# GRANDVIEW RESERVE

EL PASO PDC FILE NO.  
CDR-228

GRANDVIEW RESERVE  
DR HORTON  
FALCON, COLORADO

CONSTRUCTION DOCUMENTS  
TITLE SHEET

1 TYPICAL CROSS SECTION - TRIBUTARY 2  
SCALE: N.T.S.

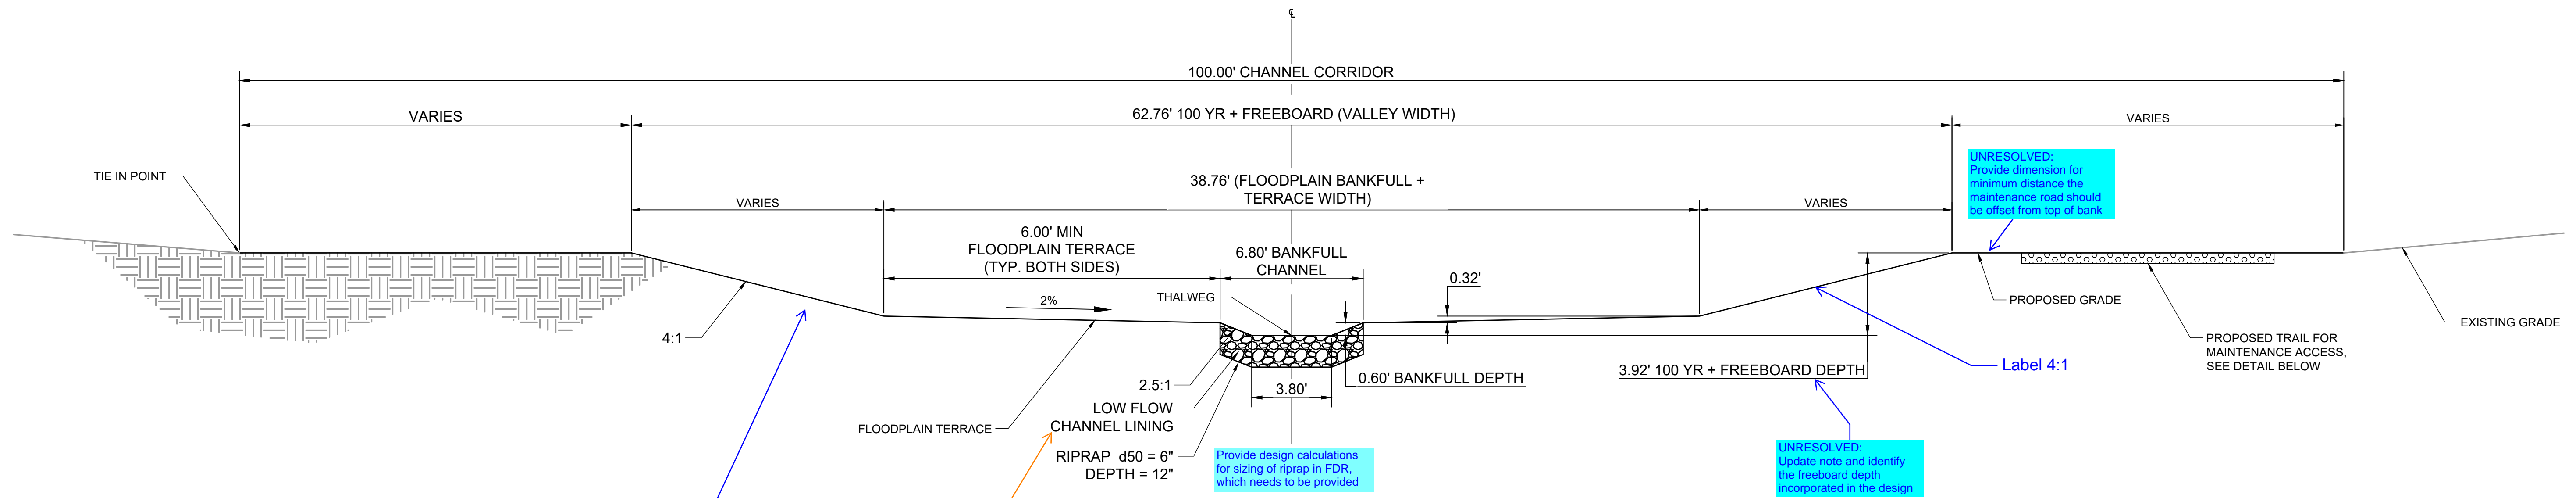
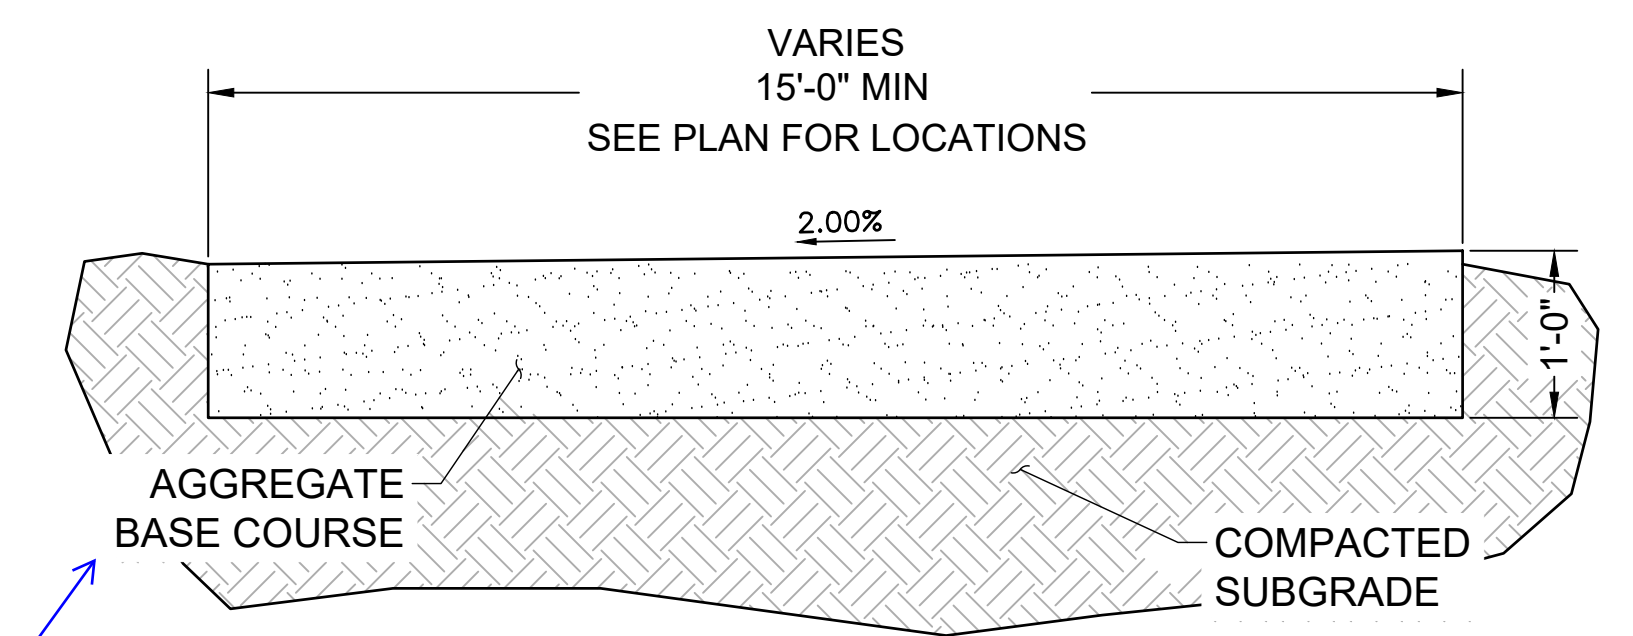
Provide detail for headwall & box culvert

SHEET  
LP1  
45

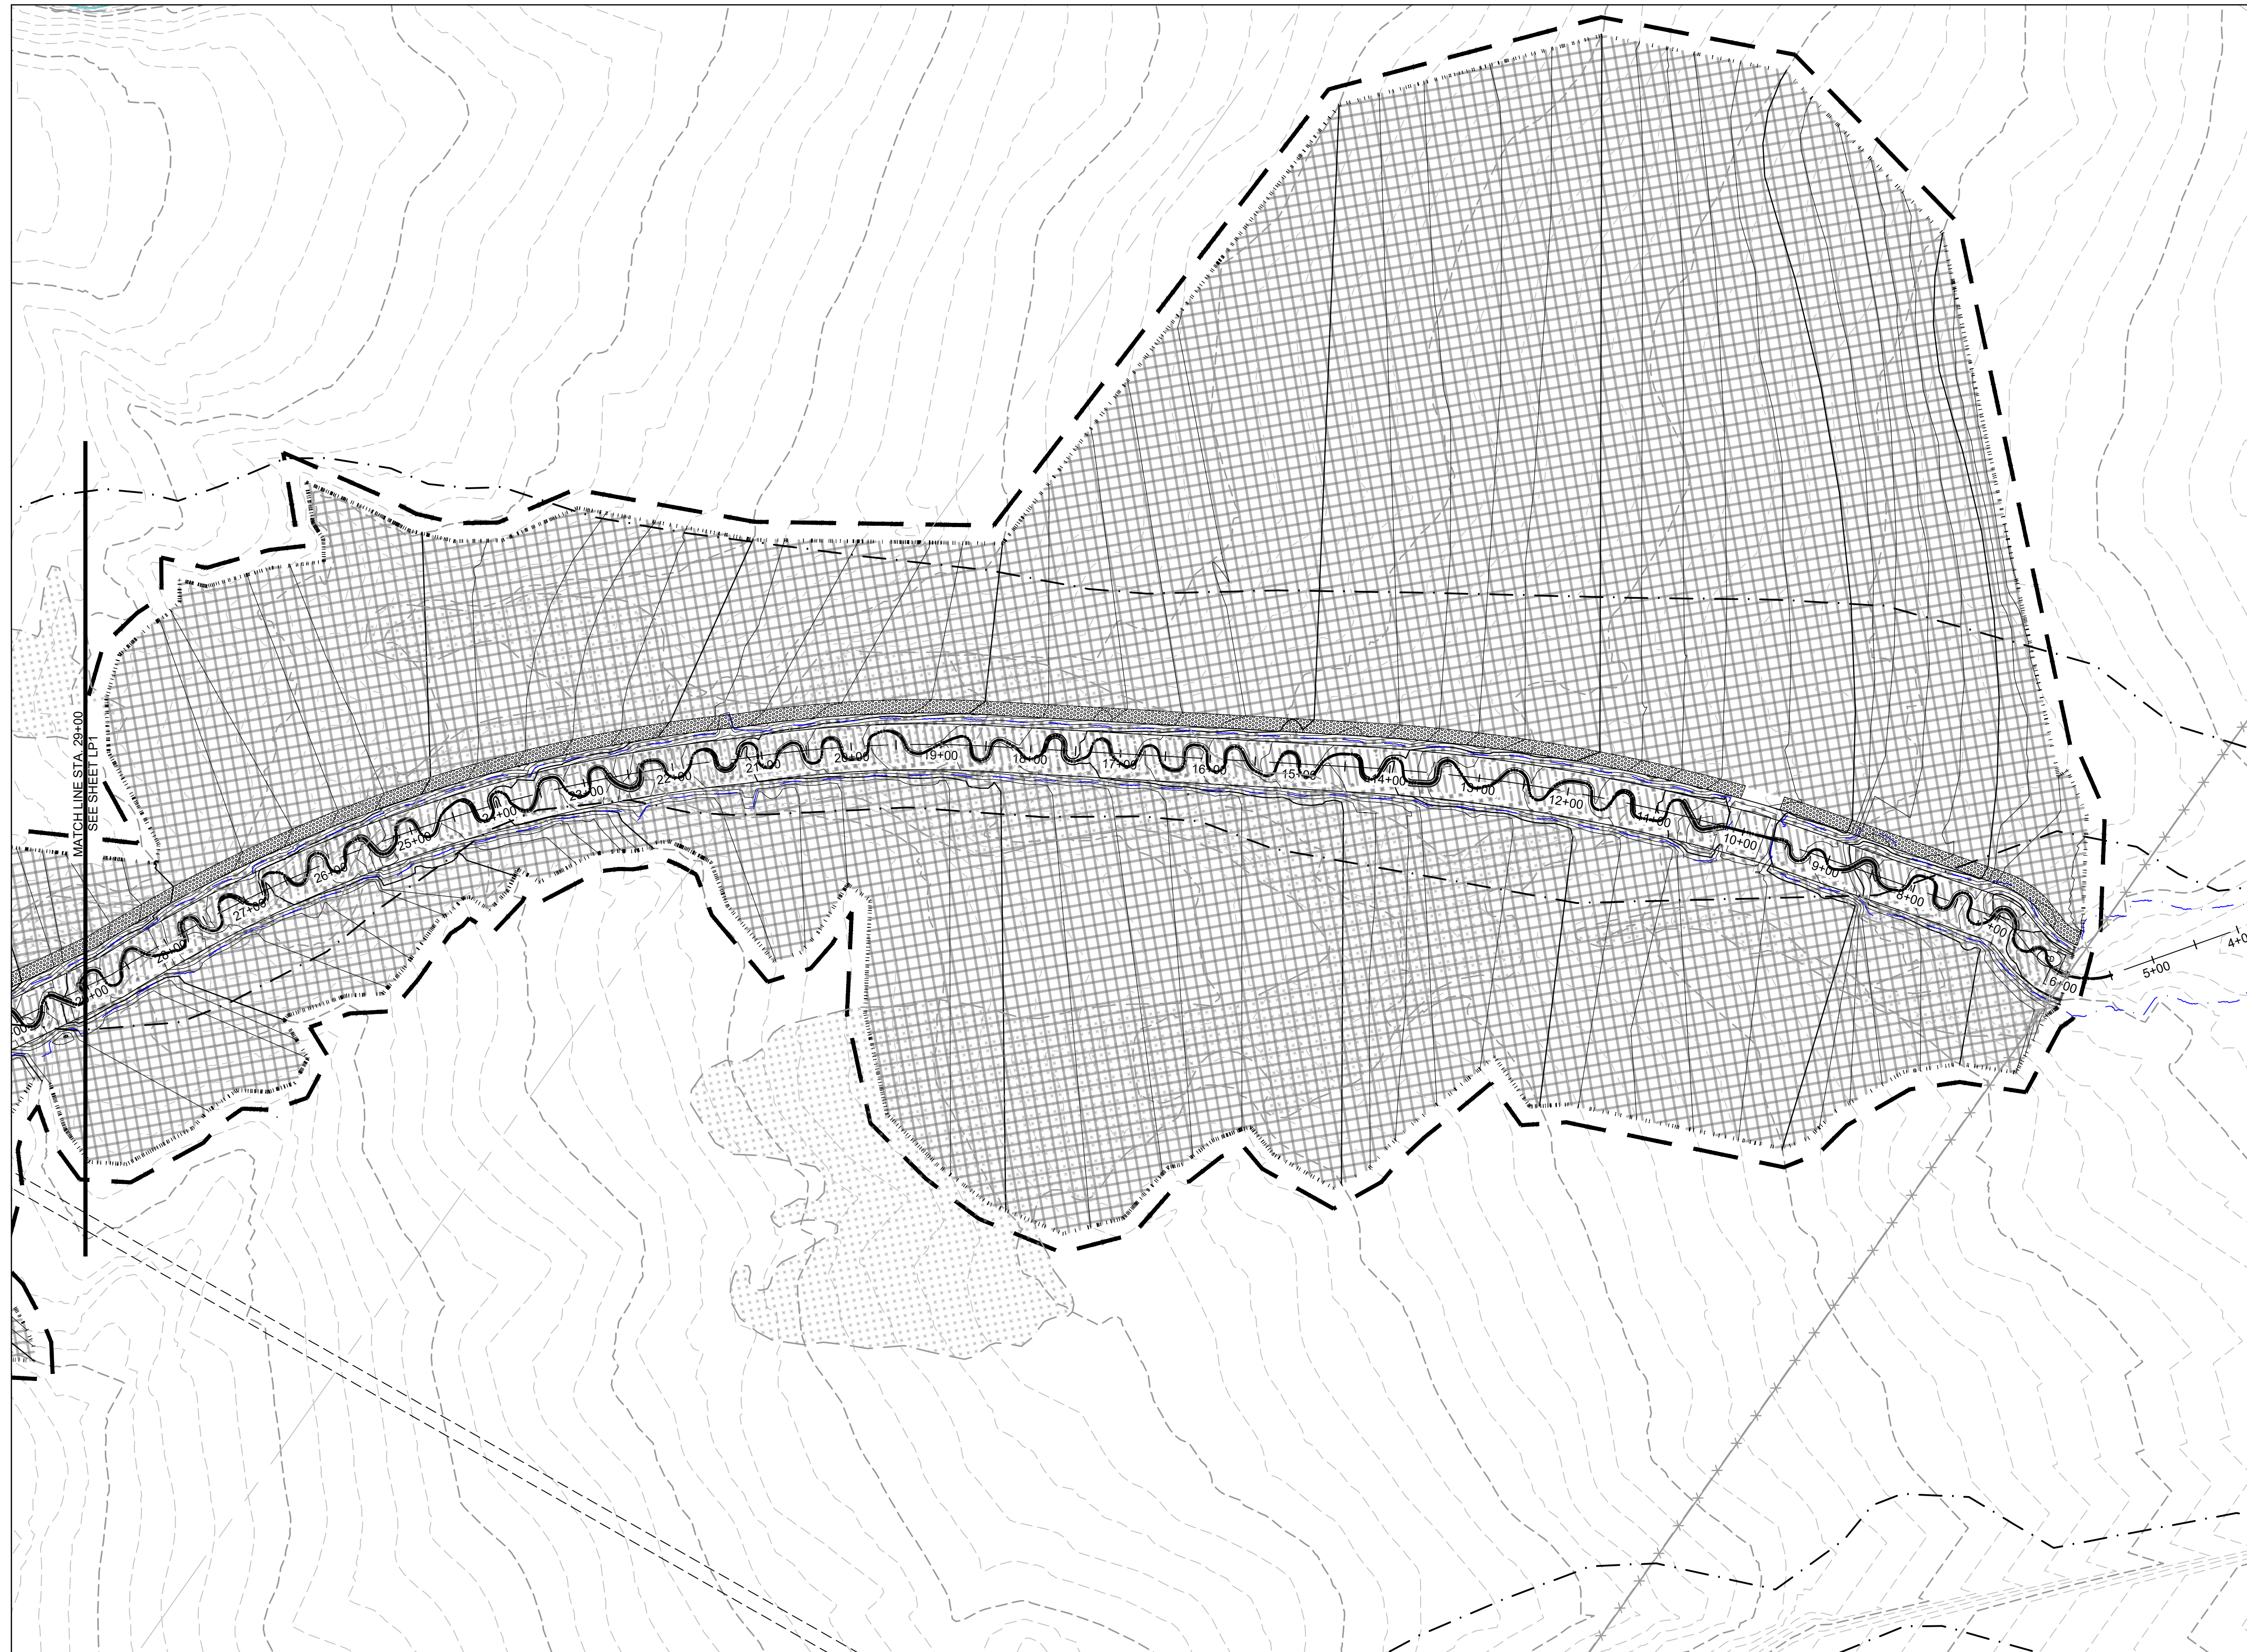
Please add these to typical section or copy the typical section and add on these sheets

SHEET  
 LP4

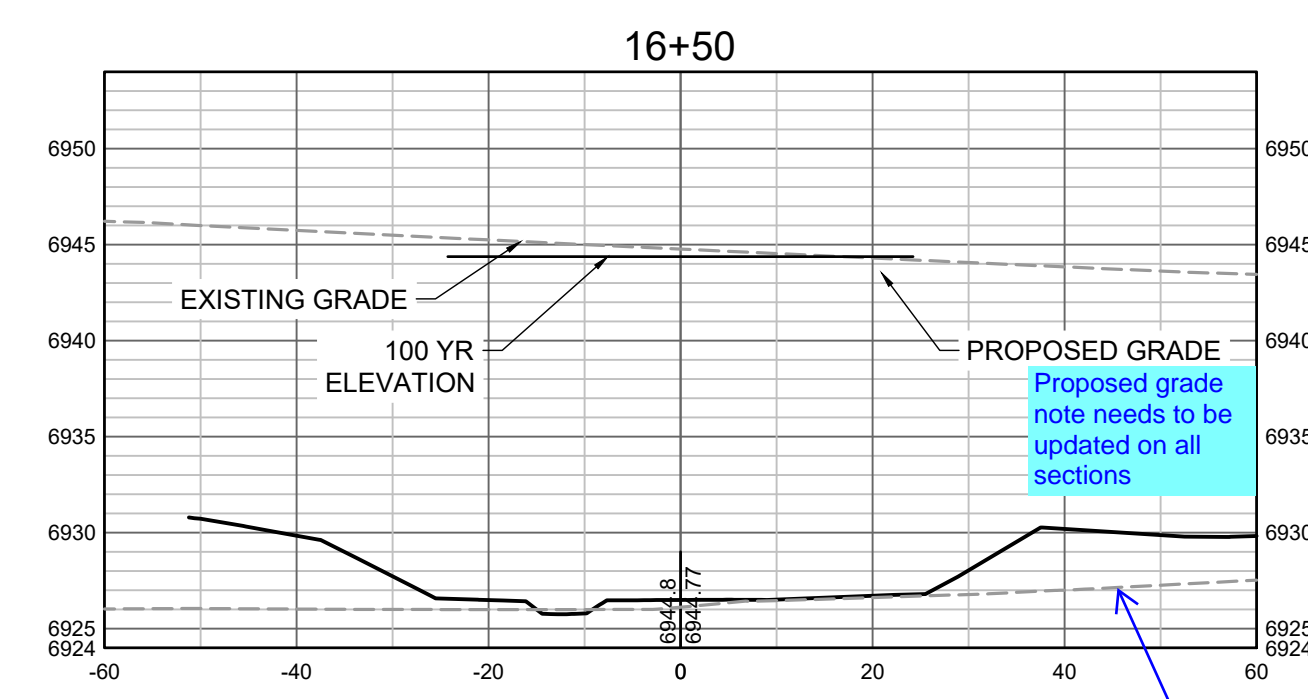
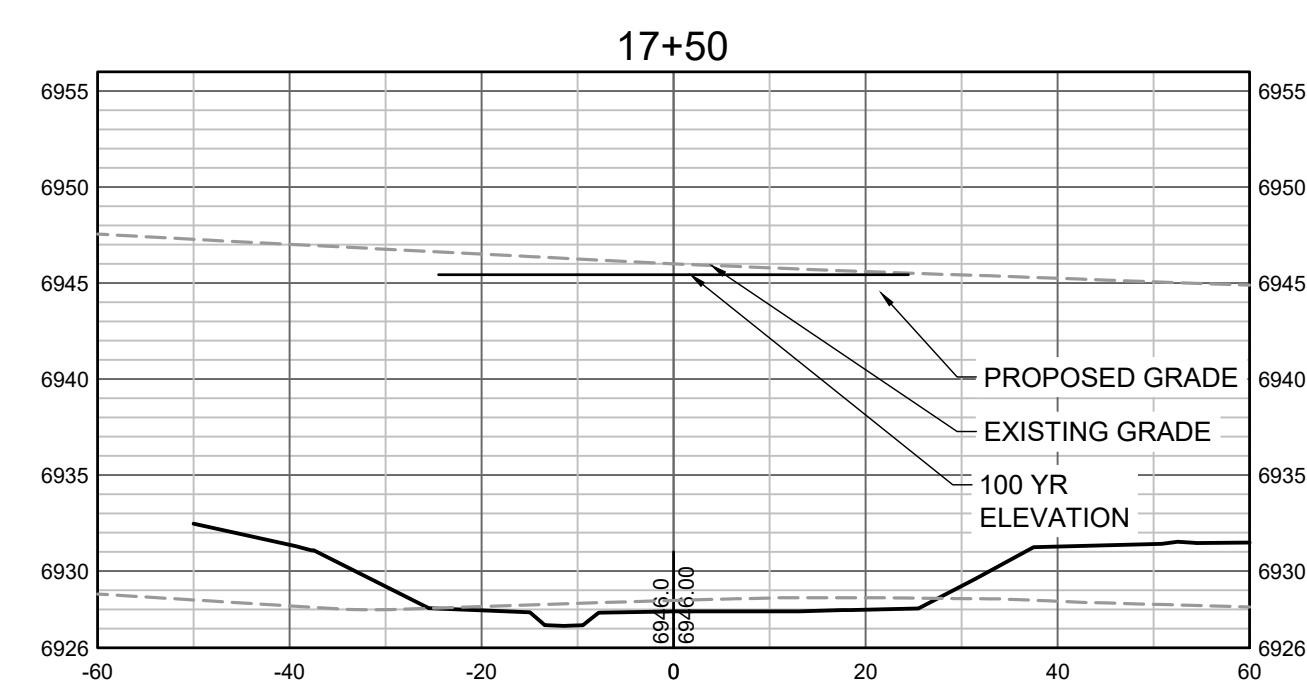
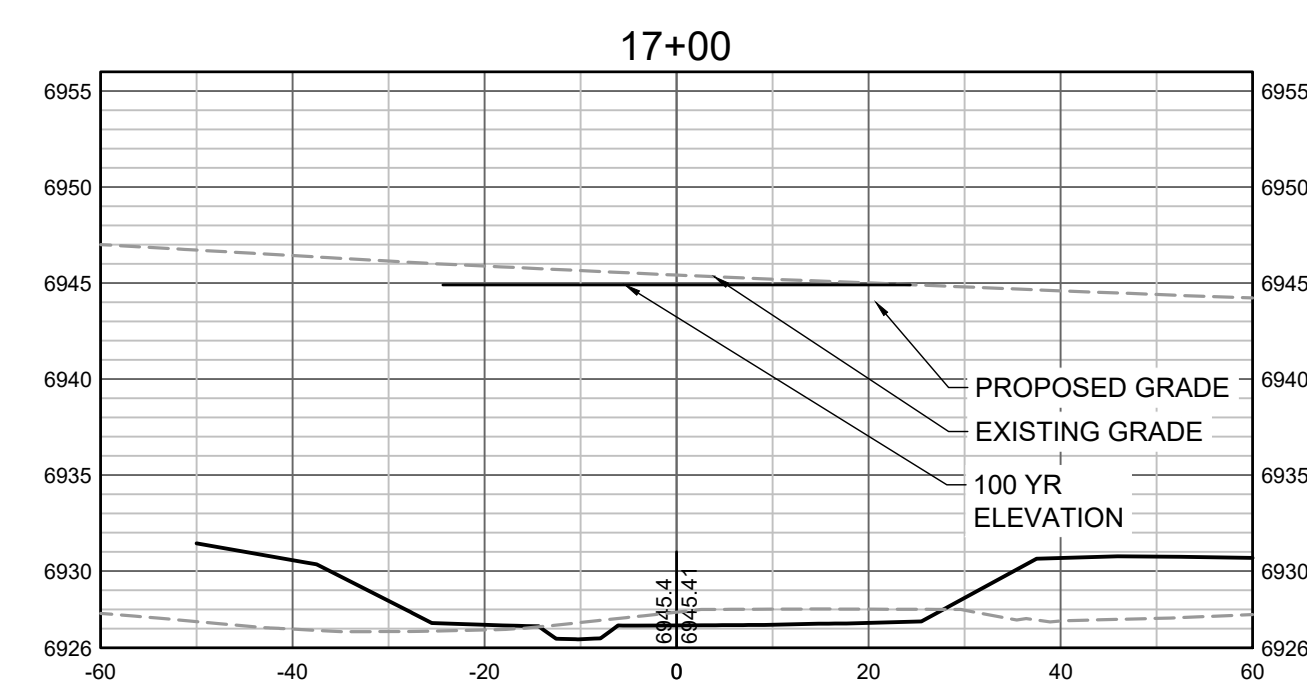
Proposed grade note needs to be updated on all sections

What is this line? Label or turn off, all sections
